COMPLETE MONOGRAPH

2021 GROUP A PROPOSED CHANGES TO THE I-CODES

April 11 – May 5, 2021
Virtual Committee Action Hearings

Figure 1
Section 1009.2.1 requires an elevator in this building

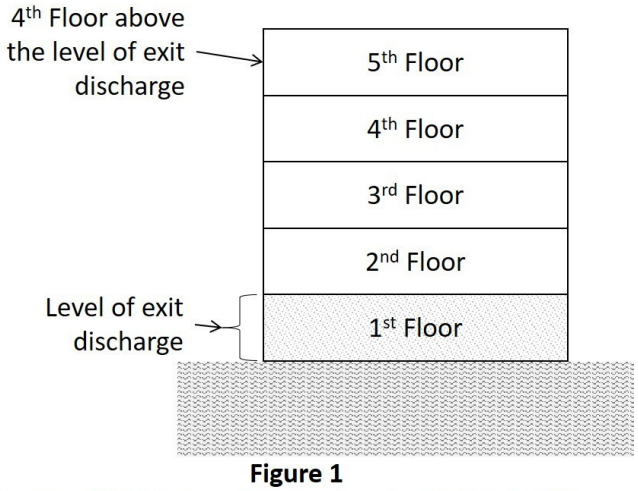
At one time, the two sections were nearly identical in their requirements. But then, the definition of “level of exit discharge” was revised from the “horizontal plane” where exit discharge begins to the “story” where exit discharge begins. Now these two sections are no longer in sync. The current code requirements are depicted in the figures below.

The intent of this code change is to correlate the two requirements once again. Since previous editions contained wording for Section 1009.2.1 which required an elevator at the same floor level as Figure 2, it makes sense to revise the wording to revert back to this requirement.

Exception for occupied roof on a building with a horizontal exit.

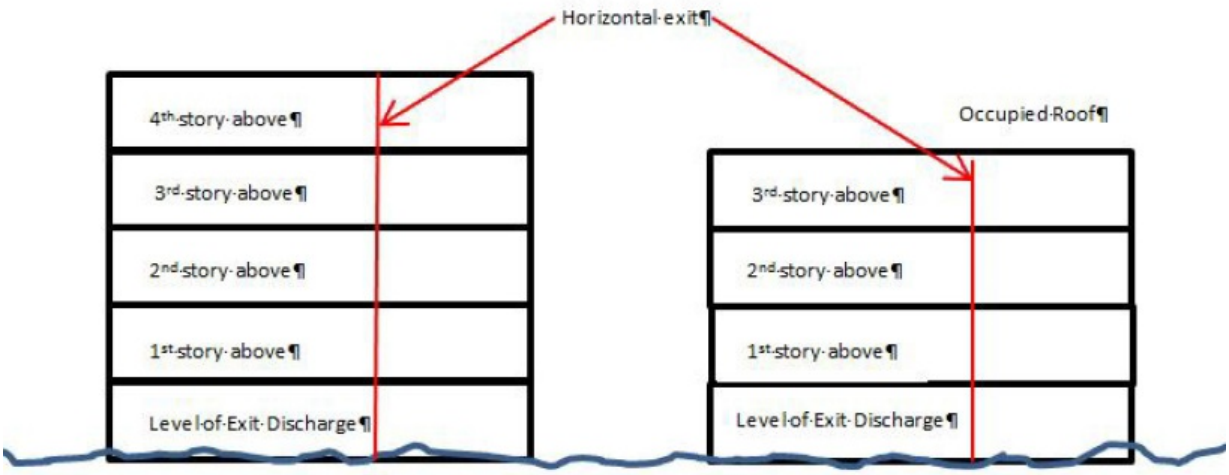
on the occupied roof to a safe area on the floor below rather then needing to transport them all the way out of the building immediately.The following is a diagram for illustration of this exception.

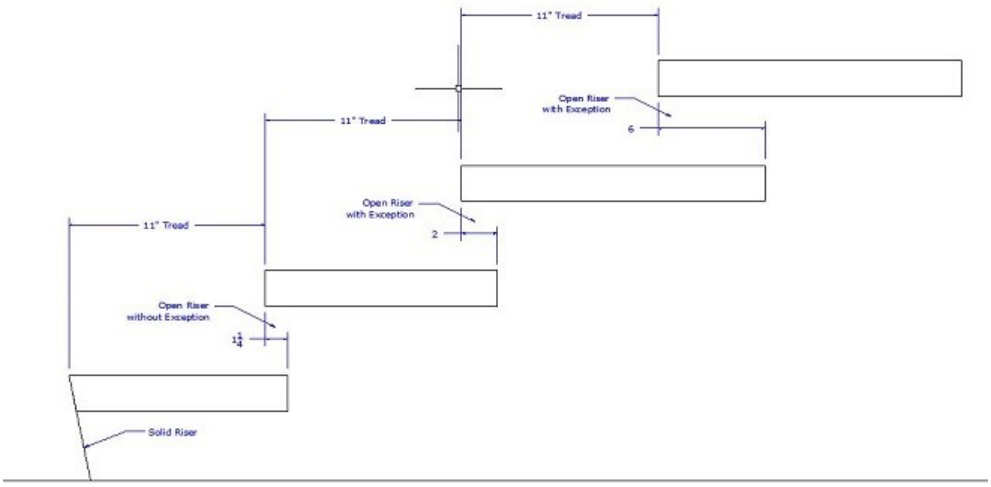
Reason Statement: When open risers are allowed per exceptions 1, 2 or 3 of Section 1011.5.5.3 Solid risers; limiting the depth of the nosing projection over the tread below does not limit or prevent how far a foot or other object may project under the tread above. The new exception to Section 1011.5.5.1 removes the maximum limit on the nosing projection allowing for the option of a deeper tread under the tread above when open risers are allowed and present.
The sketch below is provided for reference.

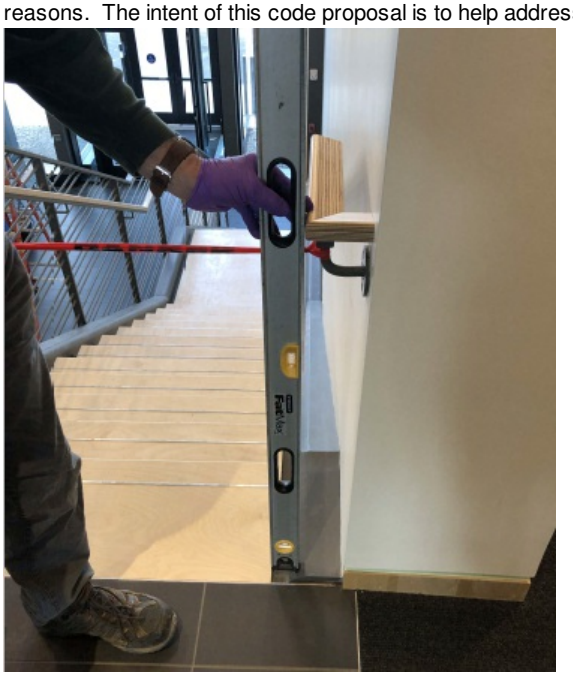
Reason Statement: Design Professionals are coming up with unique ways of construction that are not clearly addressed in the codes. Handrails are intended to aid individuals in maneuvering up and down stairs and ramps with some individuals needing to be close to a handrail for physical reasons. The intent of this code proposal is to help address this issue and not create a situation as pictured here.

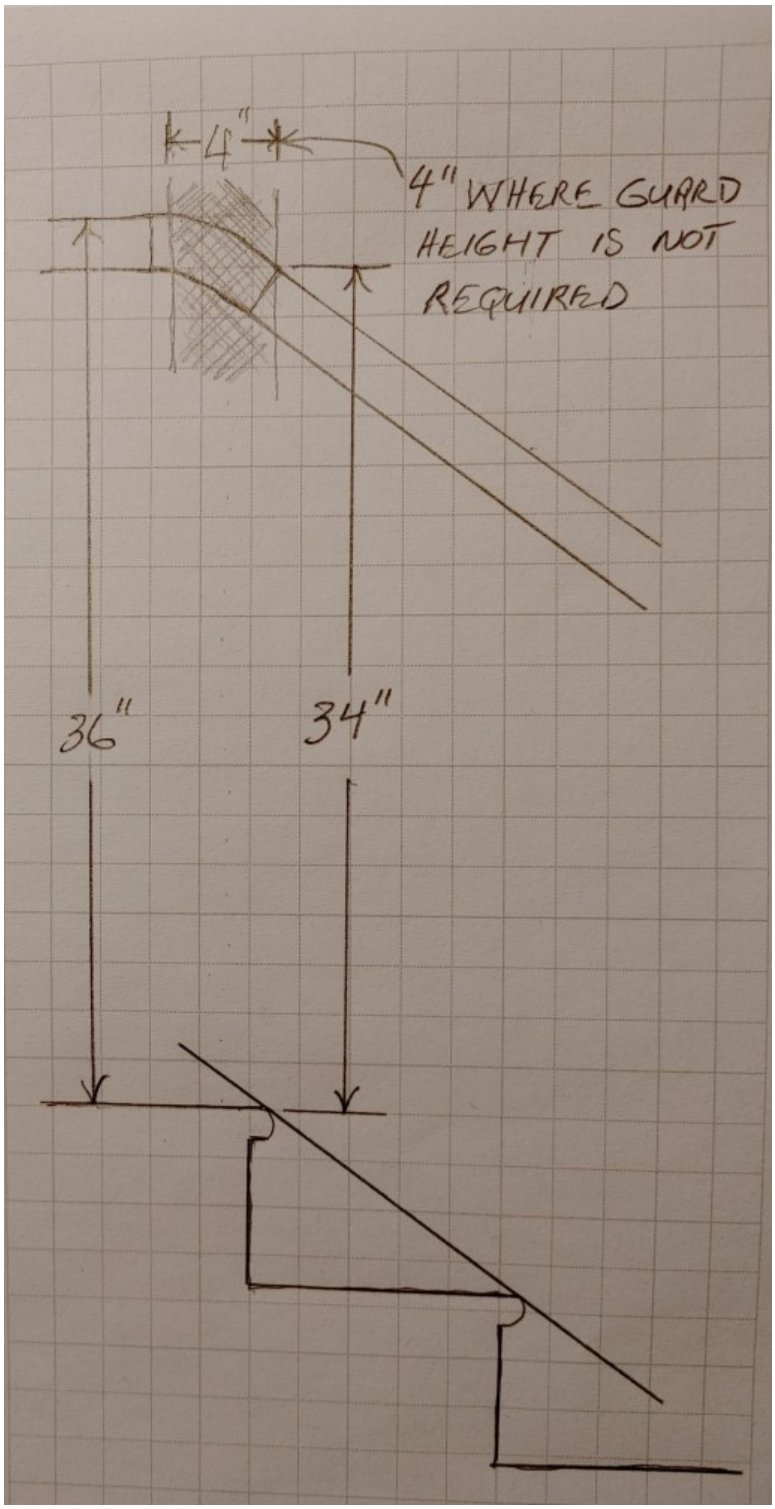
It is also the intent of this proposal to provide a four-inch “gap zone” to allow a smooth transition from stair guard height to level guard height at the top of flights. The “gap zone” limit will clarify that a guard of any height or none would be permitted. Currently in certain residential applications the code allows the handrail to serve as the top of the stair guard and requires the handrail to be continuous to the top riser. Where the nosing projects over the top riser a level guard is required at a higher height than allowed for the handrail creating a overlapping conflict. Figure 1 illustrates a very typical residential stair. The handrail serves as the top of the stair guard at the lowest possible height to allow the grasp of children. The handrail does not reach guard height until it is well past the top nosing where a taller level guard height is required. The over easing shown is simply a much safer condition that is currently not allowed by the most common interpretations. This change resolves the conflict in the requirements.

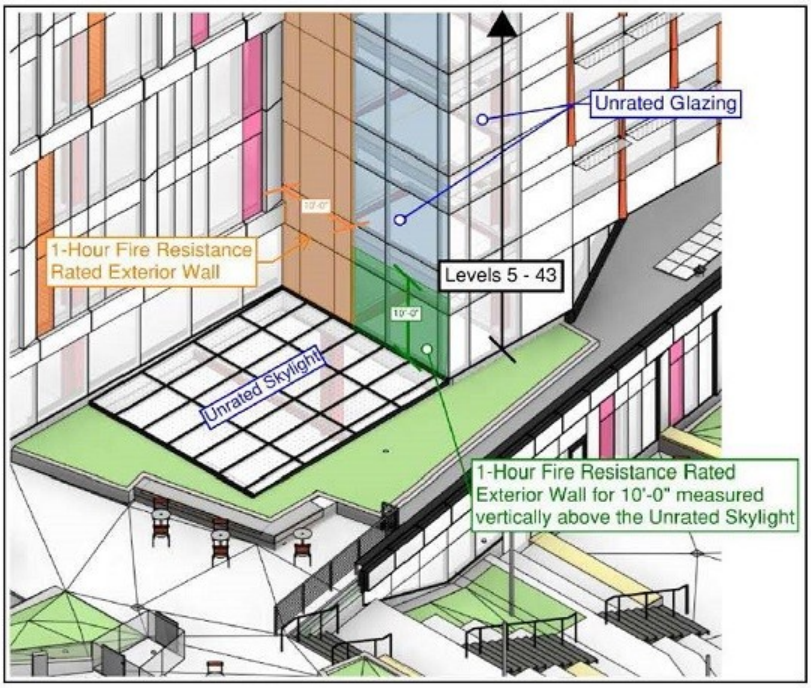
Reason Statement: This code change is needed to address designs where nonrated exterior walls of an interior exit stairway or ramp are adjacent to nonrated roof assemblies which may also have unprotected openings within 10 feet of the exterior walls of the stairway or ramp. As you can see in the attached illustration, the unrated glazed exterior wall of the interior exit stairway is directly adjacent to an unprotected skylight in the roof of a lobby below. The designer agreed to protect the exterior wall of the stairway for 10 feet above the skylight but currently there is no language in the code to require it. This proposal provides more comprehensive protection for one of the most important egress elements in Chapter 10, interior exit stairways and ramps.

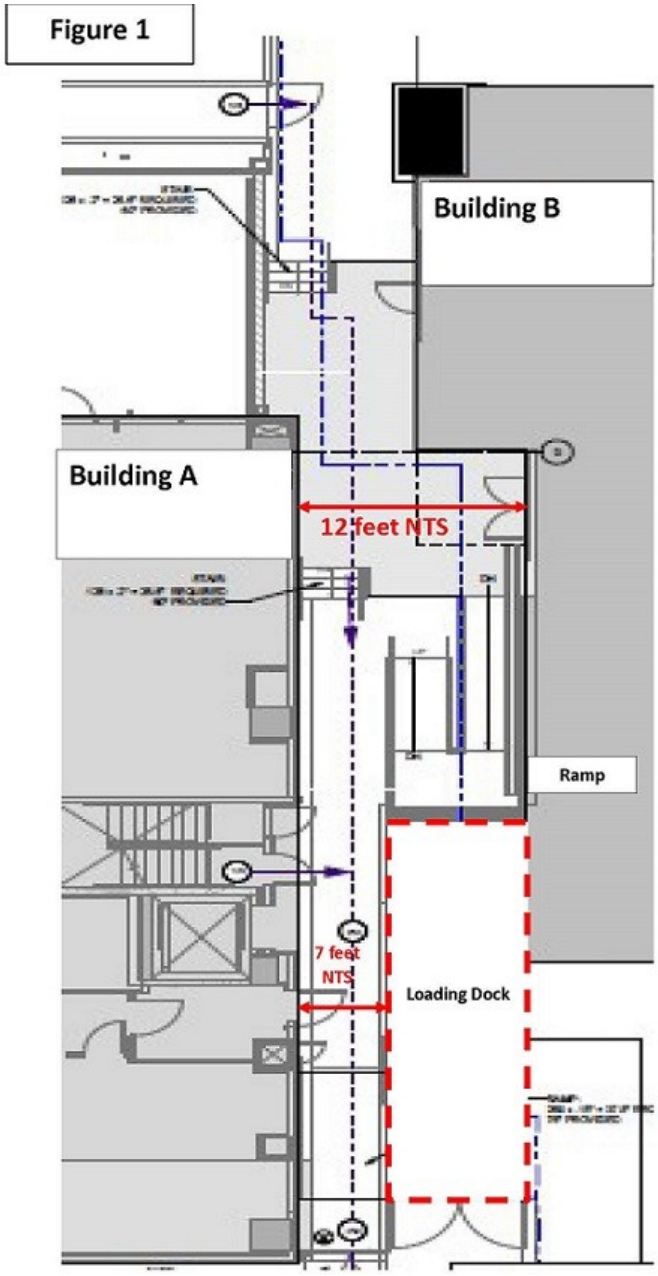
Figure 1 highlights a case where two Type IA fully sprinklered buildings share a common exit court that has a loading dock, stairs and a ramp that

direct occupants from both buildings to walk along the walls of building A. The space between the buildings is 12 feet however the walkway is located within a 7 ft wide portion of it. The IBC intends that this egress court be protected for the benefit of occupants in Building A and B. Without the addition of the exception code users will assume that the exterior wall and openings on building A do not require protection.

Transfer shower

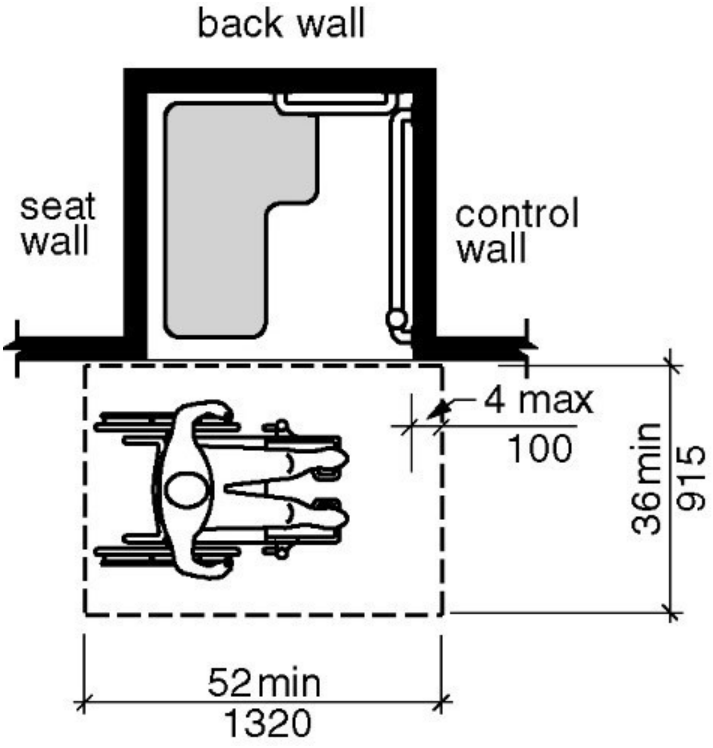
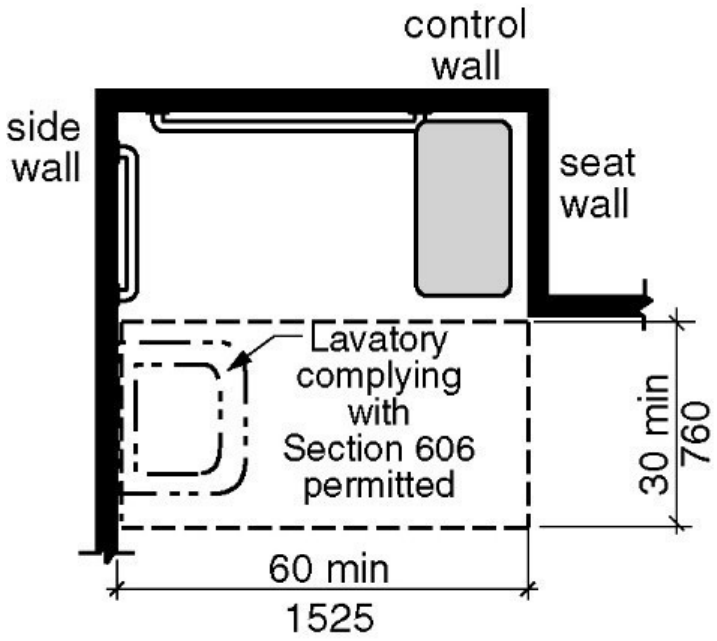
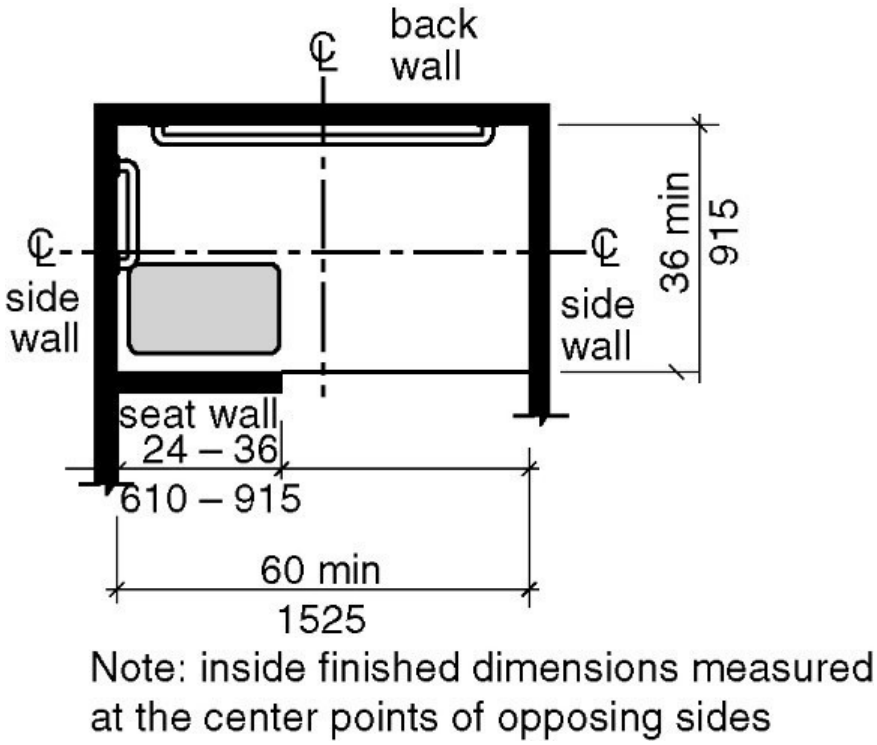
Reason Statement: If a hotel has all showers, Table 1107.6.1.1 could be read to force bathtubs in Accessible rooms. What is the reasoning/justification for this? A roll-in shower with a seat is doing double duty as transfer and roll-in. The table was written originally with the intent to require at least some roll-in showers when hotels typically provided all bathtubs. Designs for bathrooms have changed. Providing showers instead of tubs has been shown to reduce accidental falls in the bathrooms; while continuing to provide accessible options.

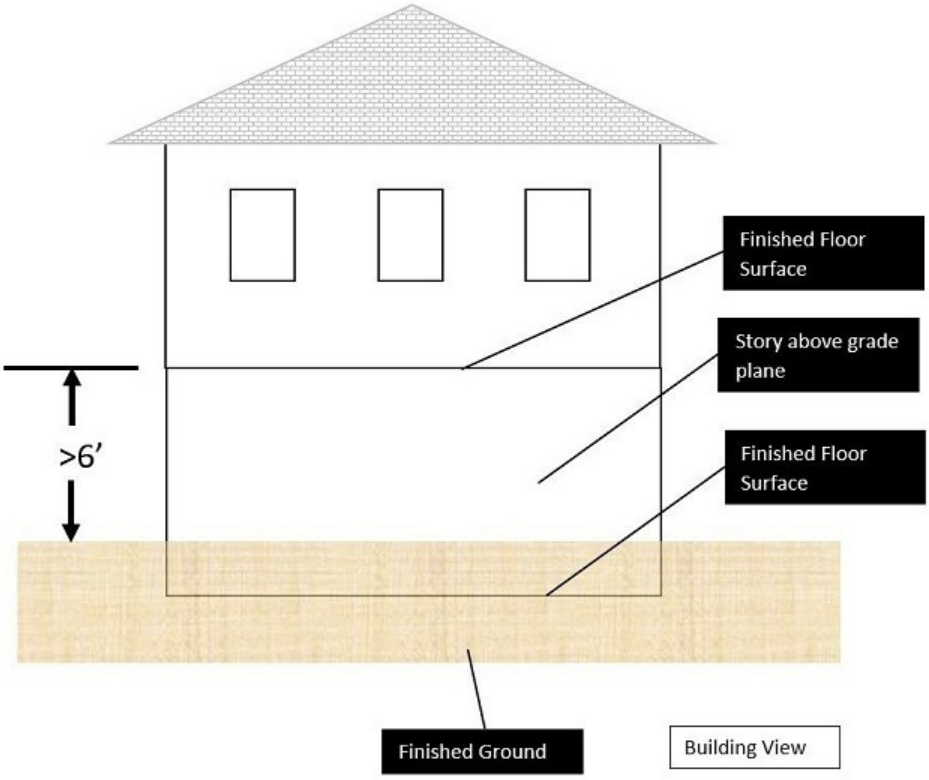
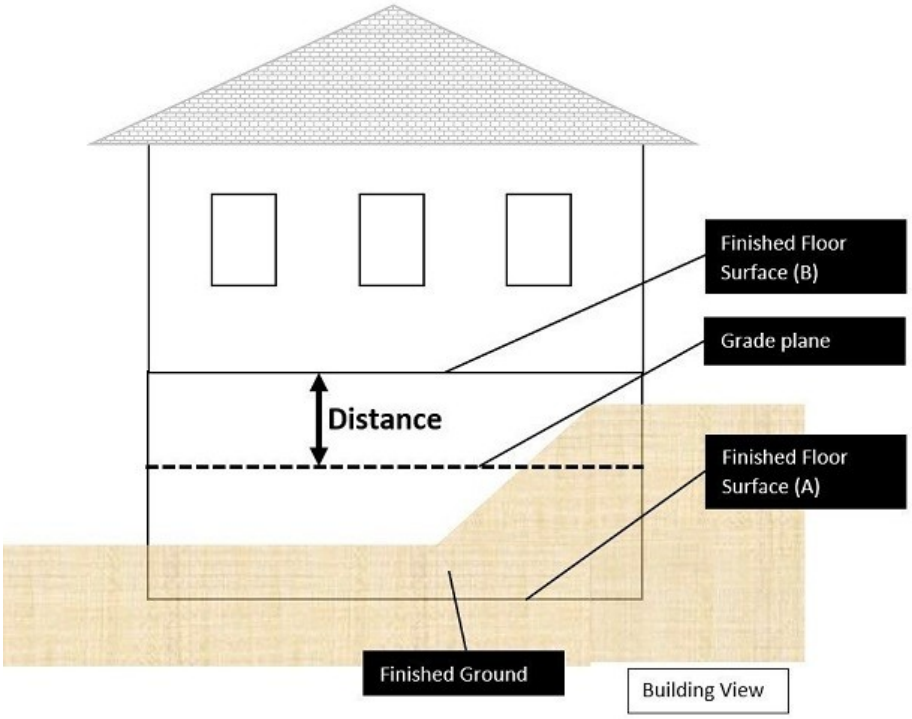
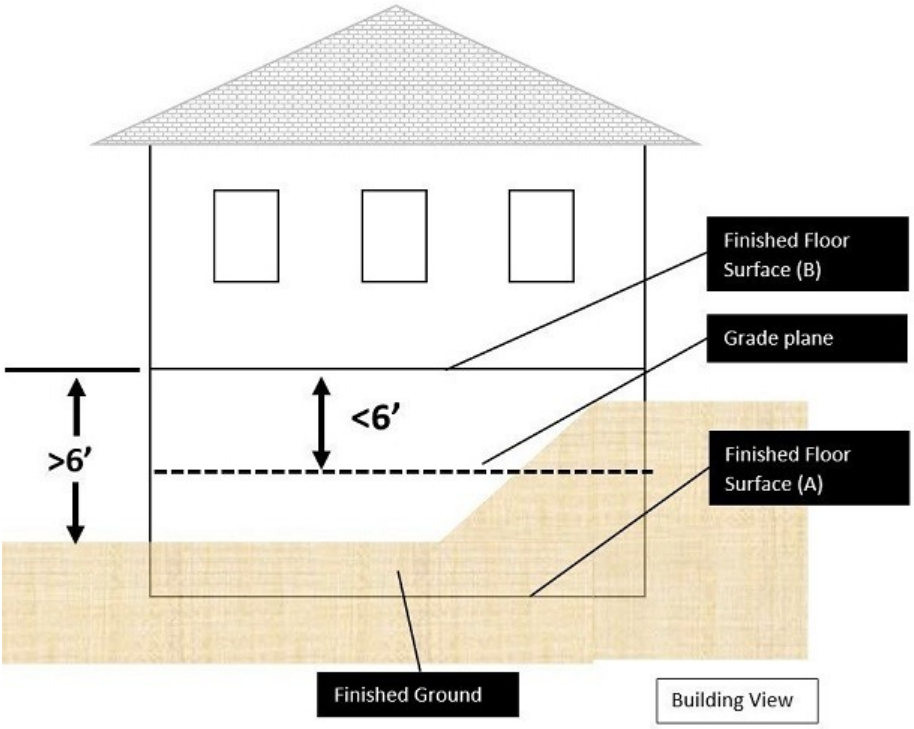
Reason Statement: When the entirety of a finished floor surface is not above *grade plane* the current code provisions describe two different scenarios that will still define it as a *story above grade plane*. The first provision specifies that the finished floor surface will be considered a story above *grade plane* if the finished story next above is more than 6 feet (1829 mm) above *grade plane*, where *grade plane* is defined as a "reference plane representing the average of the finished ground level adjoining the building at all exterior walls." A hypothetical simple example can be imagined with a level finished ground level, which is shown below, that fulfills this requirement.

Not all buildings and dwellings are constructed on level finished ground and can instead be constructed on uneven finished ground as shown below. According to the current code provisions, if the dimension labeled 'distance' is greater than 6' then the finished floor surface (A) corresponds to a *story above grade plane*.

The proposed change to the code applies to the figure below because more than 50 percent of the total building perimeter is more than 6 feet (1829 mm) above the finished ground level. In the figure below the current code provisions would not characterize the finished floor surface (A) as part of a story above grade plane and would instead finished floor surface (B) would apply to the first *story above grade plane*.

Figure 4. Comparison of Building Heights for Group R-1 and R-2 sprinklered occupancies based on proposed code change.

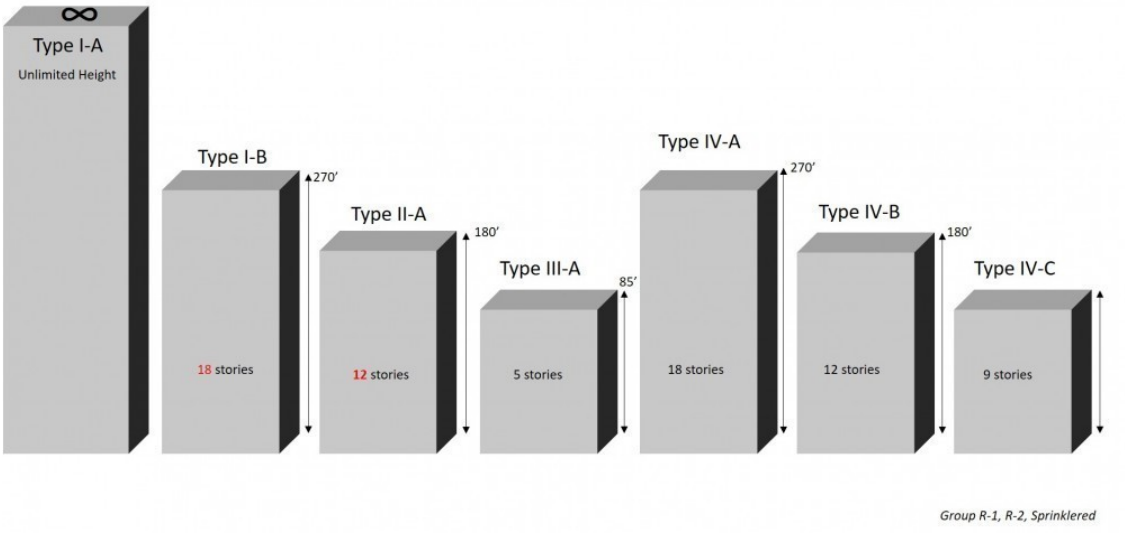
For the proposed code change, Figure 4 illustrates no increases to building height over what is permitted by Section 403.2.1.1, and does not intend to present any decrease in the level of safety from the previous code edition based on the introduction of footnote i.

Figure 503.1 Location of PV Support Structures on Open Parking Structures.

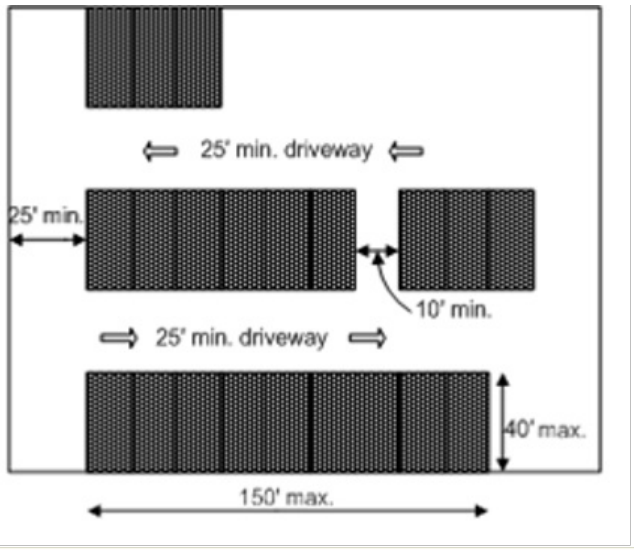
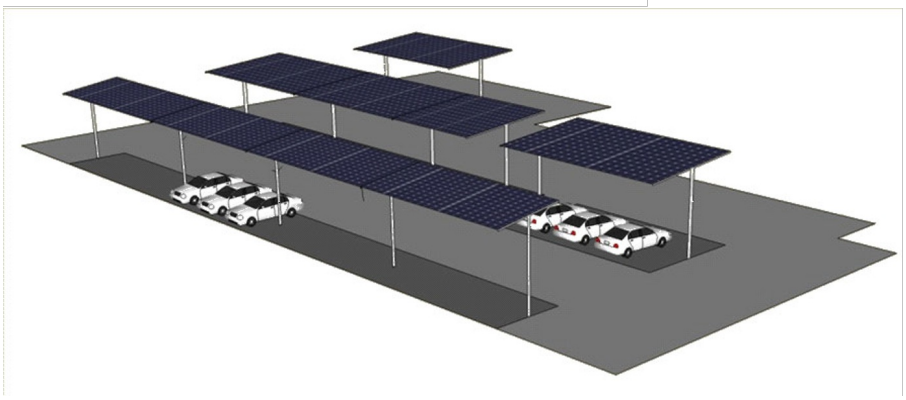
2. Photovoltaic (PV) support structures installed on the roof of an open parking structure shall not constitute an additional story or additional floor area and shall be permitted to exceed the height limit of a building where all the following conditions are met (see Figure 503.1):
   2.1. The area within the perimeter of PV support structures has maximum rectangular dimension of 40 feet by 150 feet (12 195 mm by 45 720 mm).
